ADDENDUM NO. 15 TO PROJECT NO. 44578

**CONSTRUCTION WORK - PLA
MAJOR BUILDING RENOVATIONS FOR THE
MANHATTAN FORENSIC
RELOCATION
MANHATTAN PSYCHIATRIC CENTER
600 EAST 125th STREET
WARDS ISLAND, NY 10035**

November 6, 2015

DRAWING NUMBER: A-100-2E

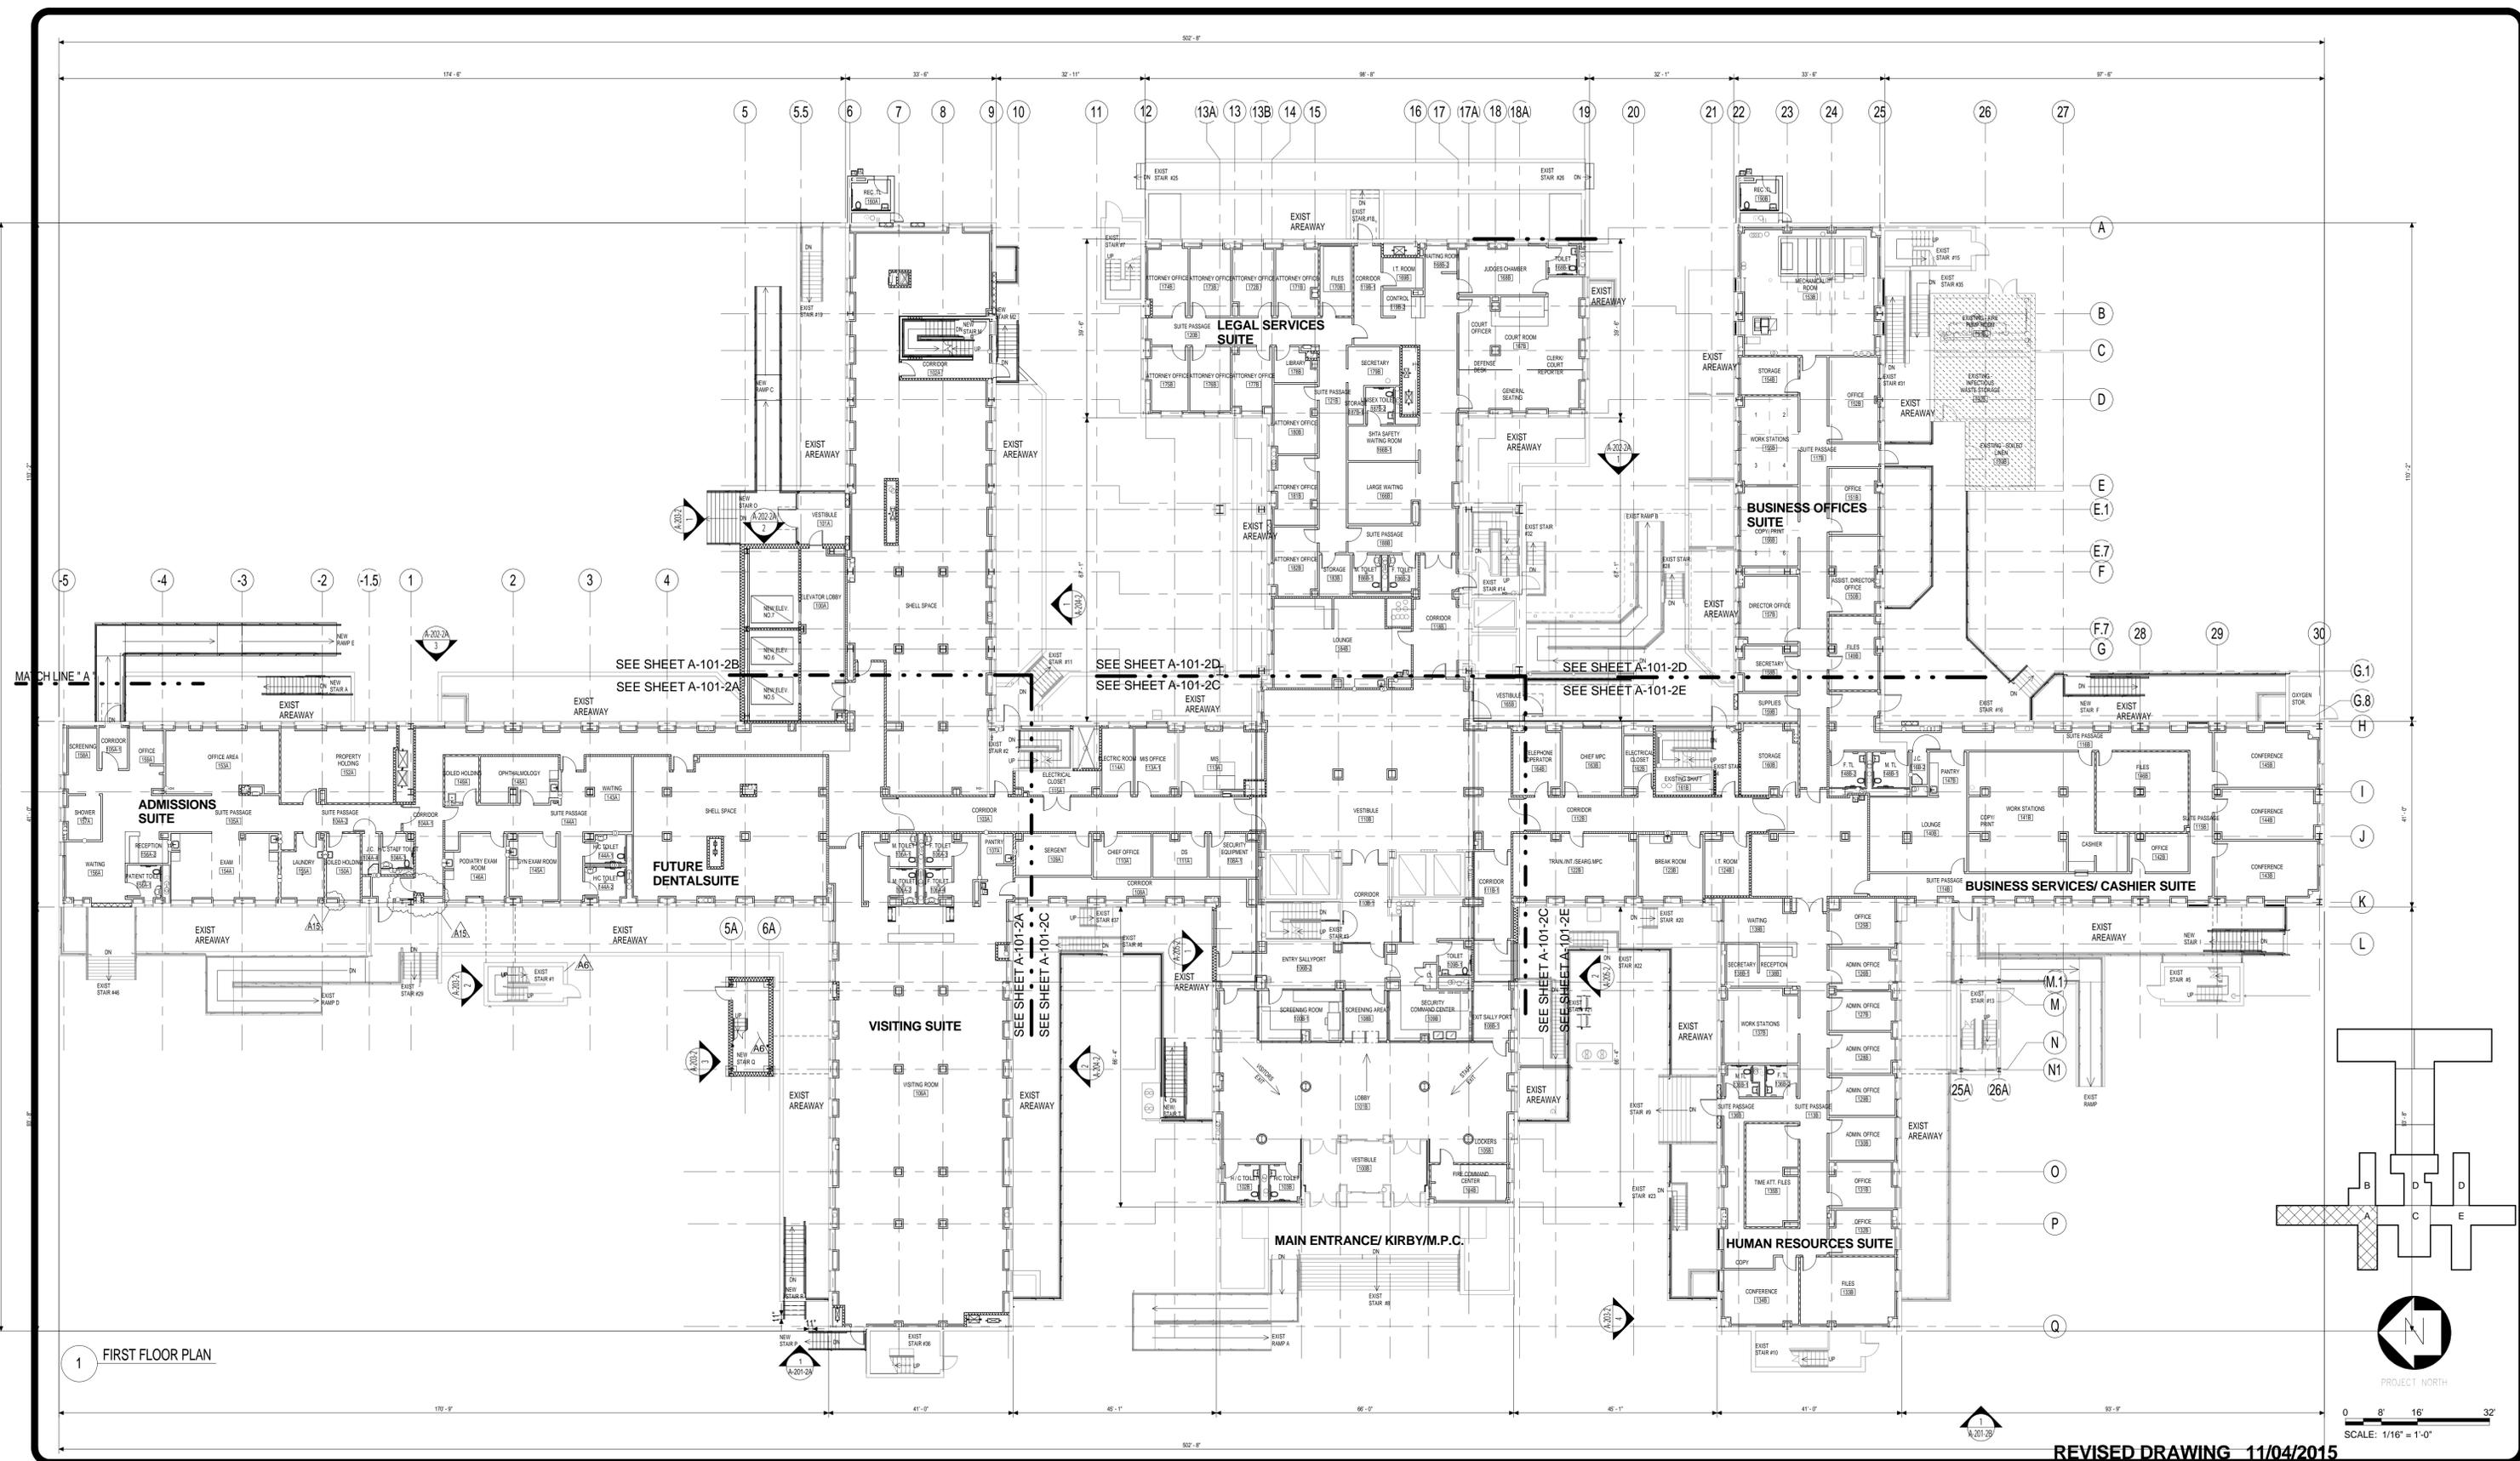
3. Drawing Nos. A-100-2 and A-100-2D: Provide a 2 ft x 2 ft wall access door to IT CABLE TERMINAL CONNECTOR BLOCKS (installed in BP-1), at Col. line west of E at 17.
4. Drawing No. A-101-2C: FIRST FLOOR PLAN, PART C: Delete partition tags labeled "B" and "B4" from glass partitions along Col. lines L and N between 18 & 18A and along Col. line 17A between K & L and M & N.
5. Drawing No. A-117-2 (REVISED 09/24/2015 and issued with Addendum #8), ROOF PLAN - PART A:
 - a) Move detail tag 3/A-907-2 from current location on Col. line H between 8 & 9, to the intended location on the screen between Col. lines K & L and 8 & 9 to reference the section through the privacy screen.

DRAWING NUMBER: A-101-2A

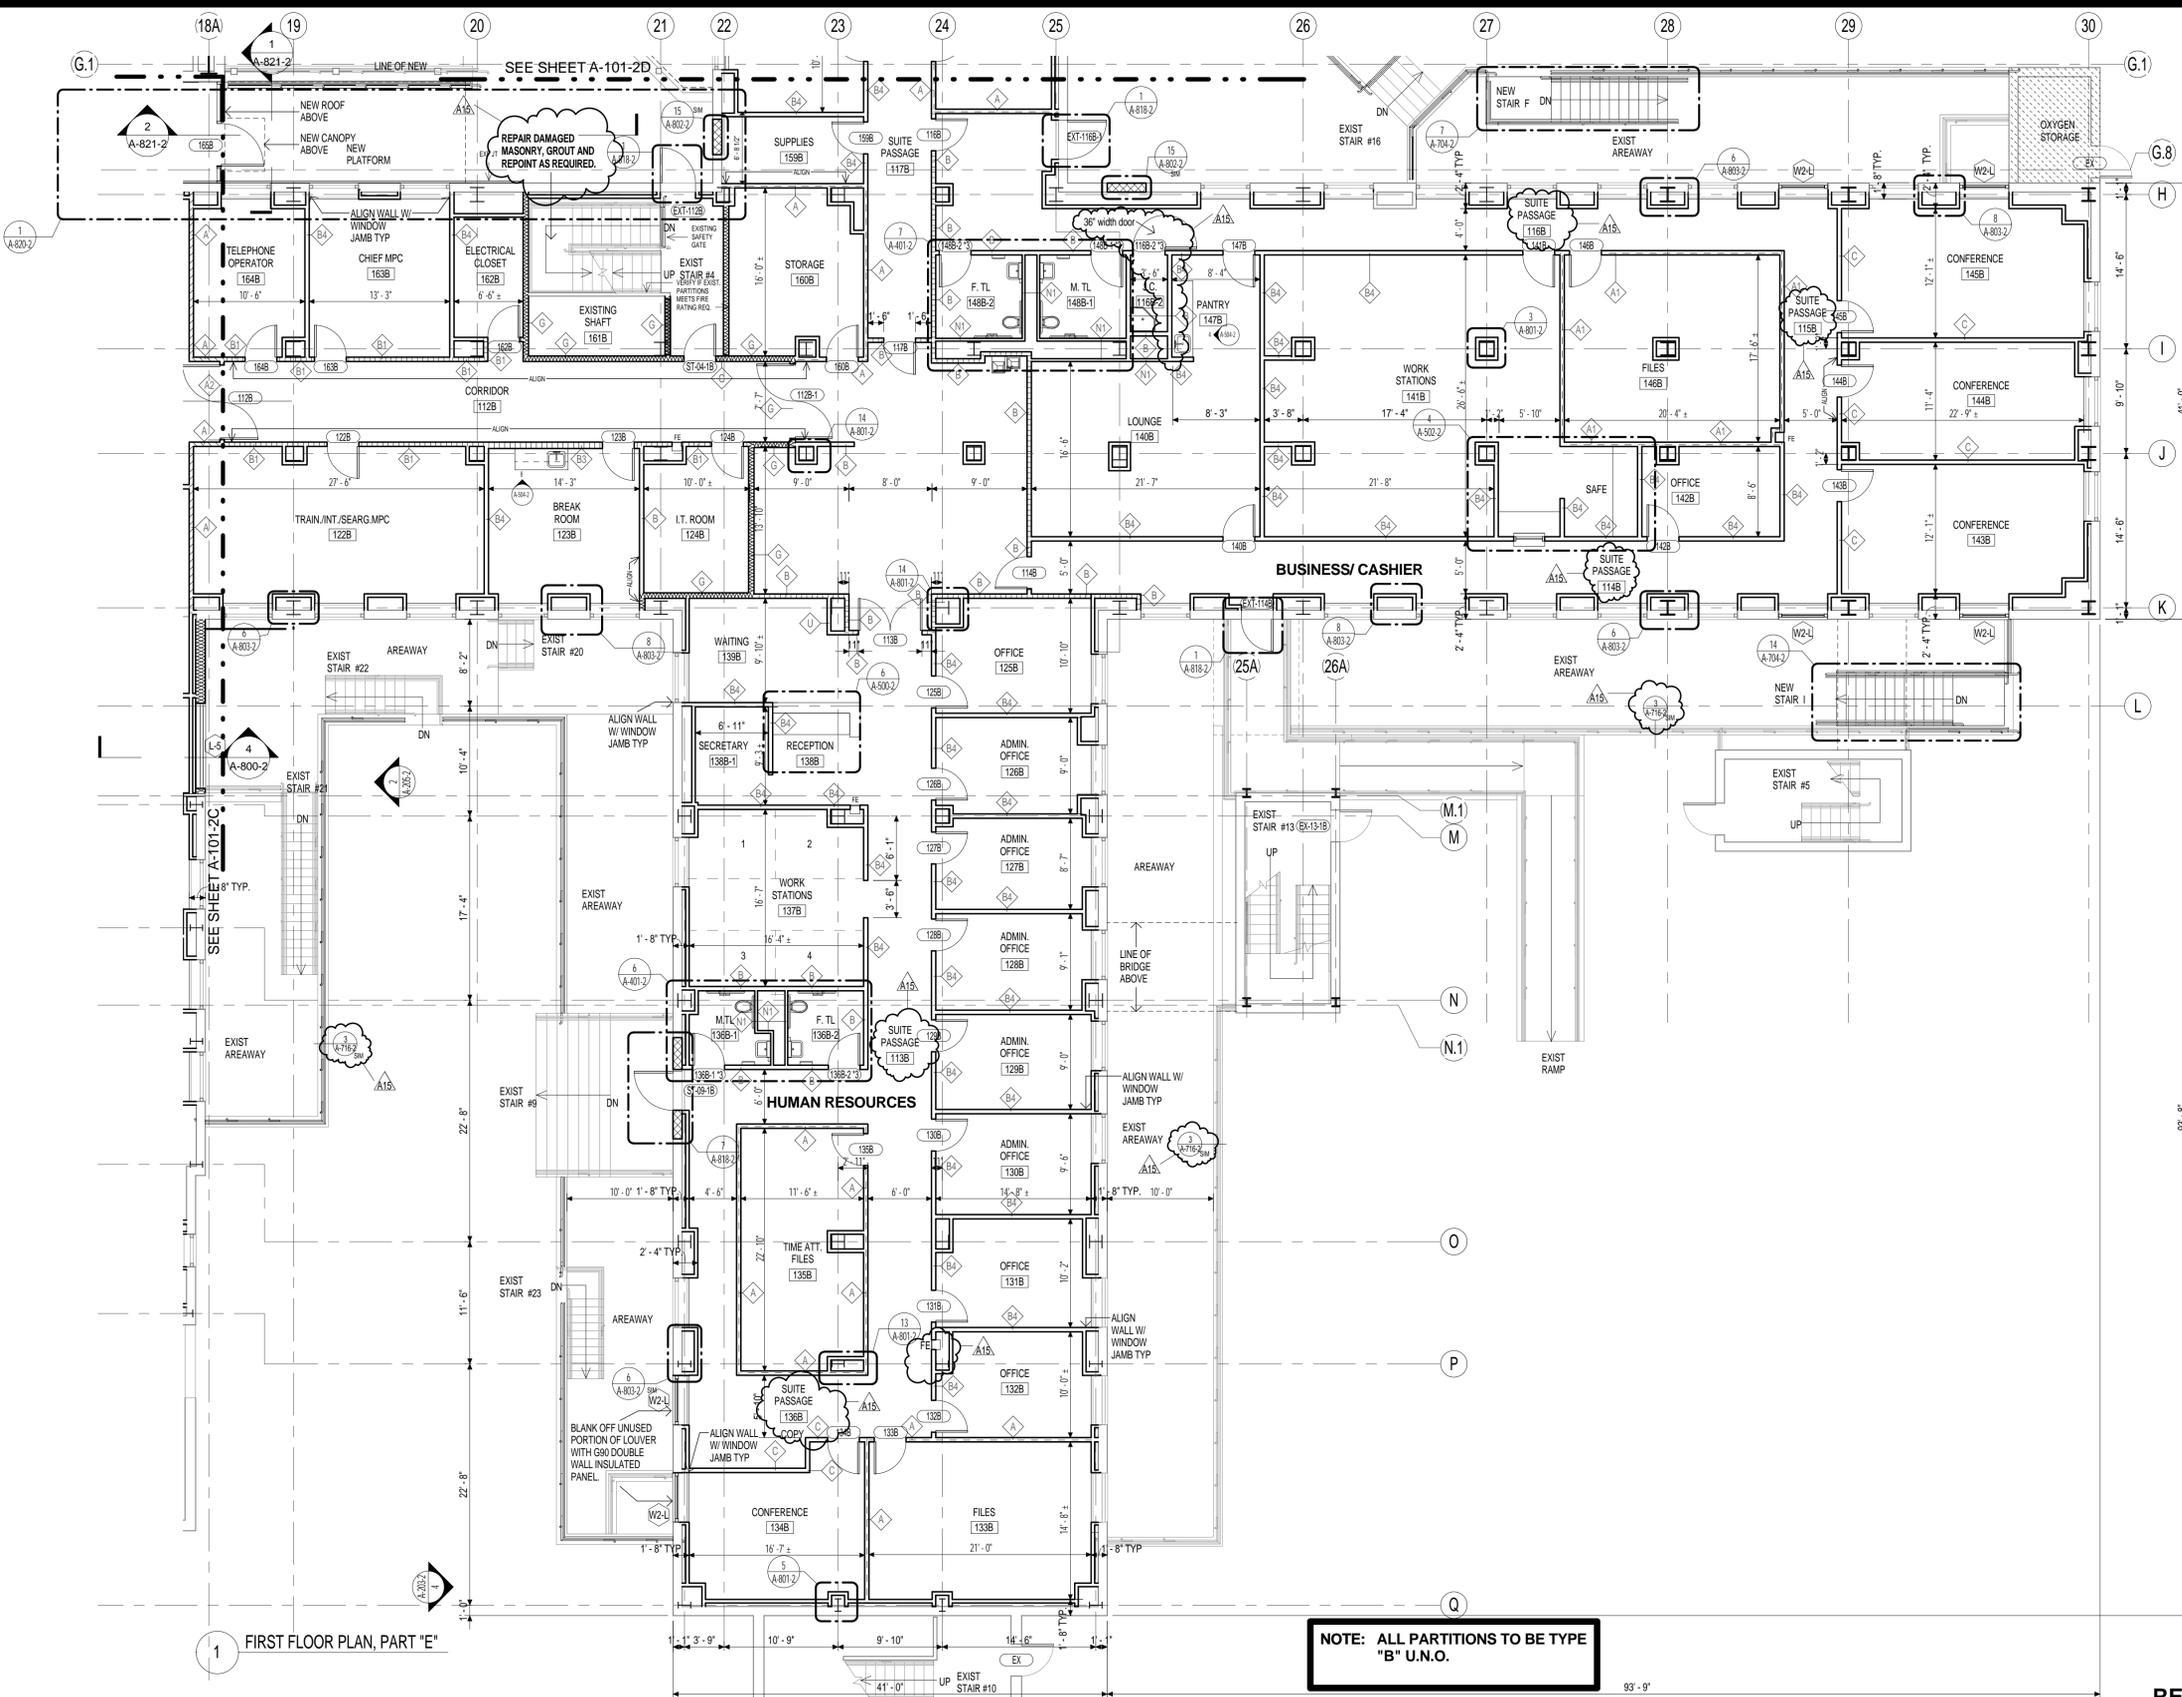
11. Drawing Nos. AF-101-2A, FIRST FLOOR ROOM FINISH PLAN, PART A:
 - a. Add floor finish "EP-2", and ceiling paint finish "P-1" to Stair #1.
 - b. Add floor finish "EP-2", wall finish "P-1" and ceiling paint finish "P-1" to Stair Q & Stair #36.
 - c. Add floor finish "VT-2", wall base "WB-1", paint finish "P-1" and ceiling paint "P-1" to new Vestibule 104A-5 at Col. line K between -1.5 & 1.

BUILDING NUMBER: 102	DRAWING NUMBER: M-101-2A
SHEET

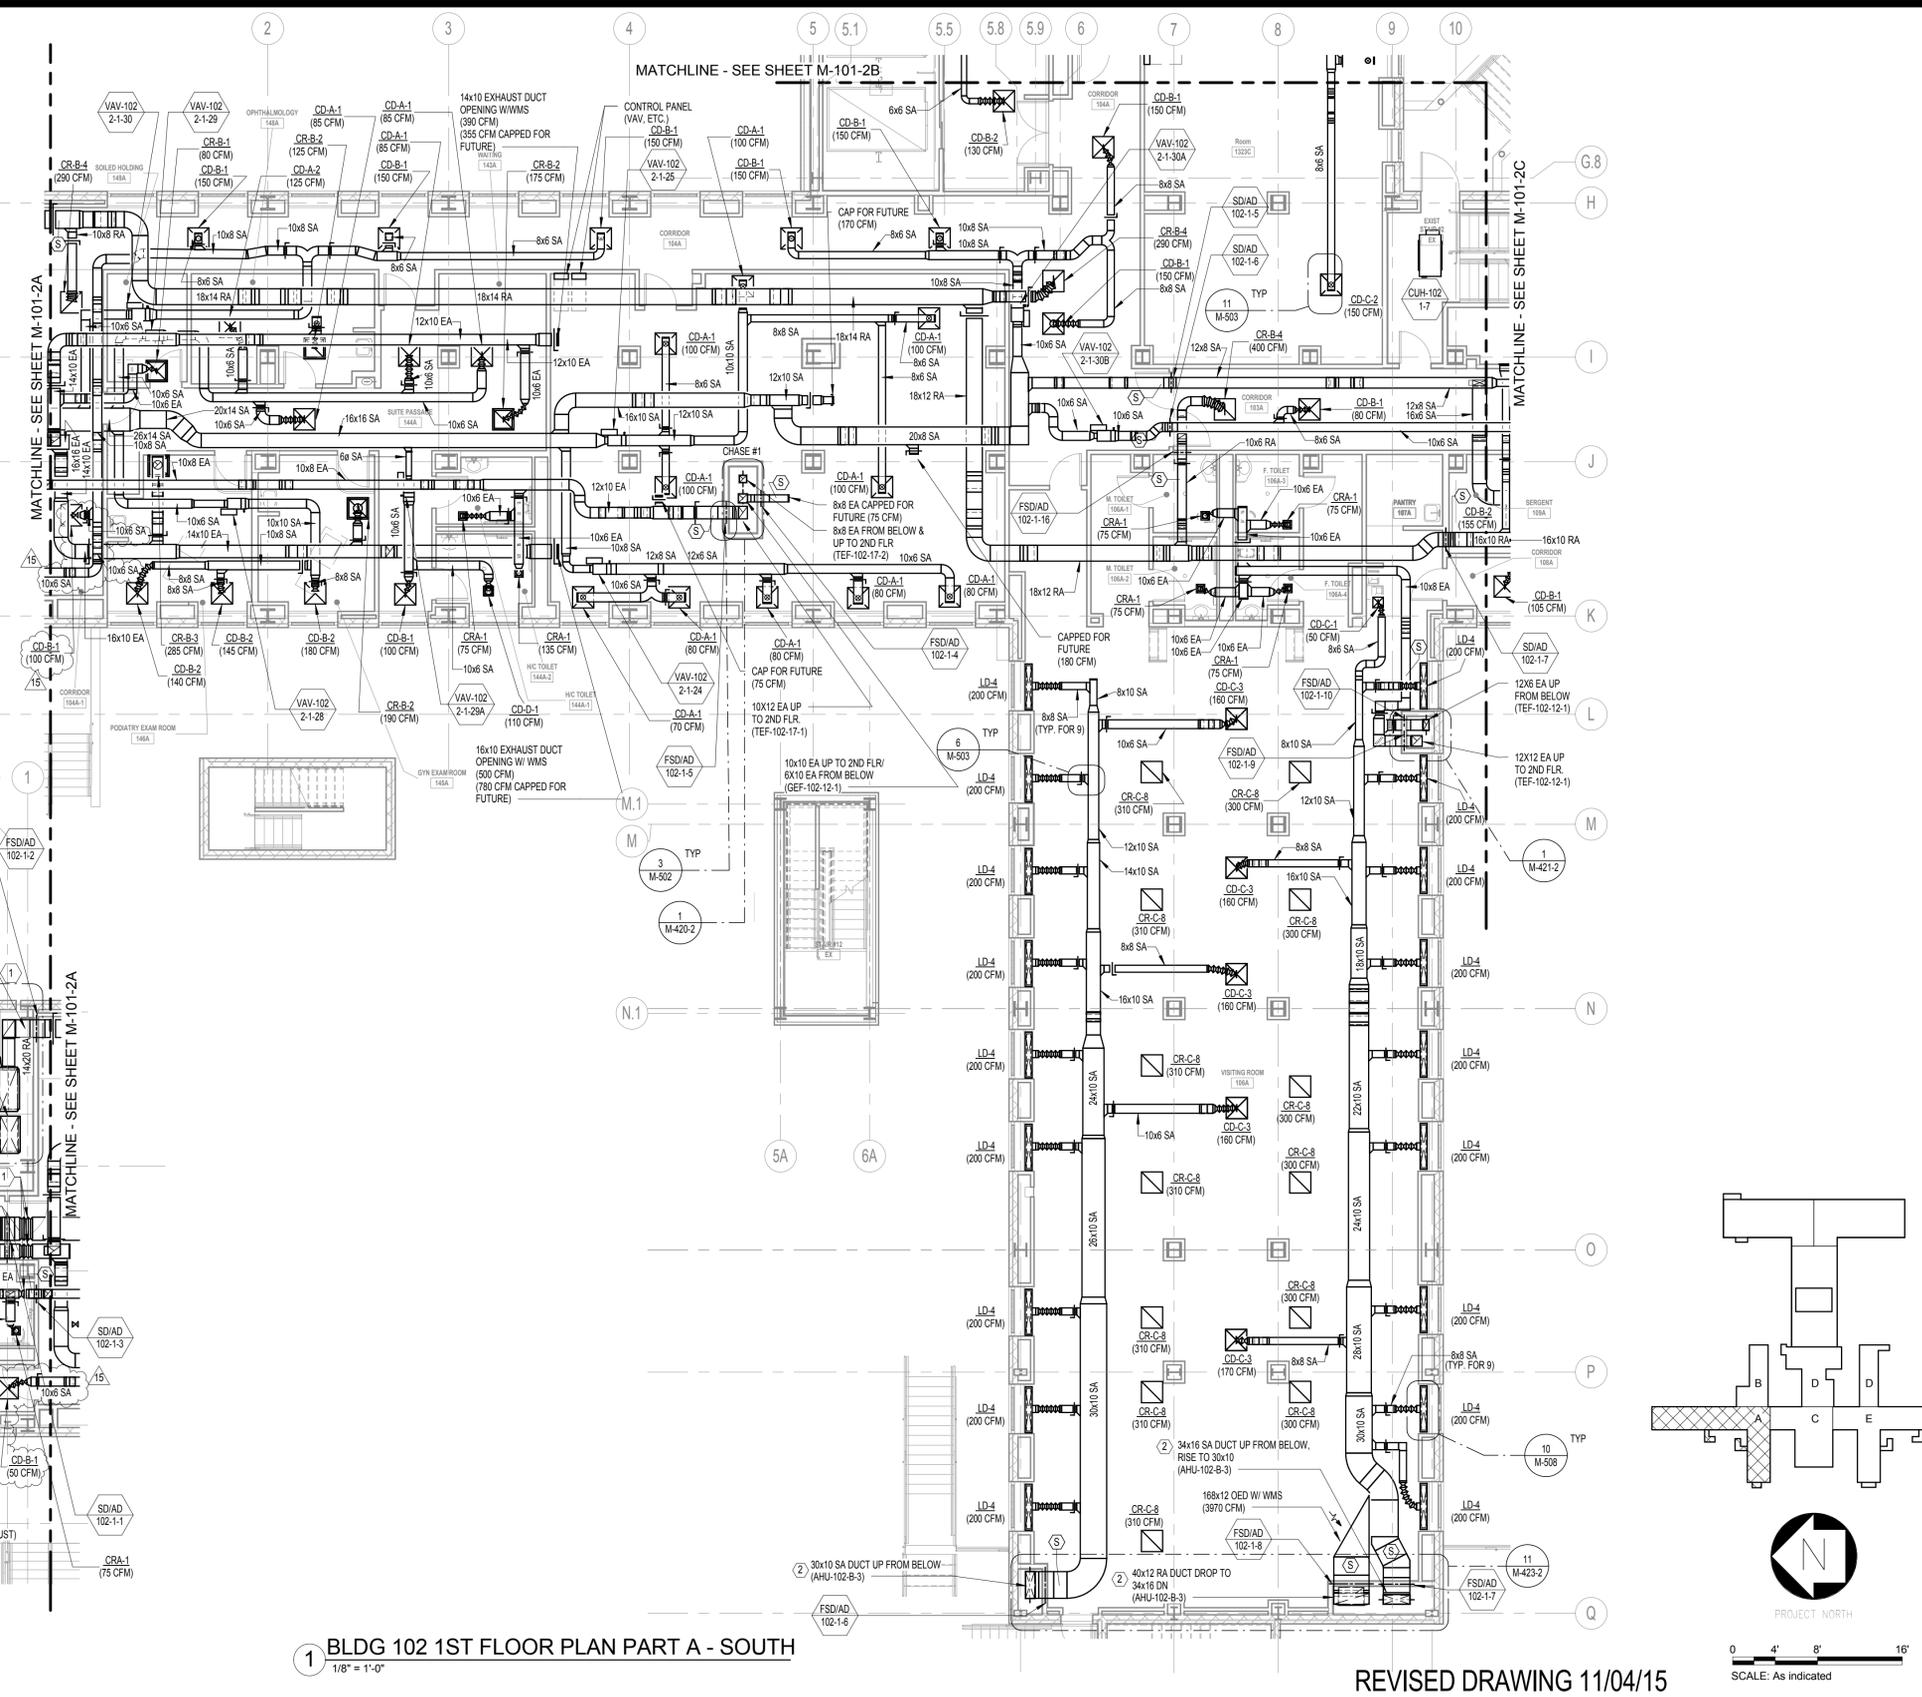
15. Revised Drawings:
 - a. Drawing No. M-101-2A noted “REVISED DRAWING 11/04/2015” accompanies this Addendum and replaces the same numbered originally issued drawing, and any same numbered previously issued Revised Drawing.
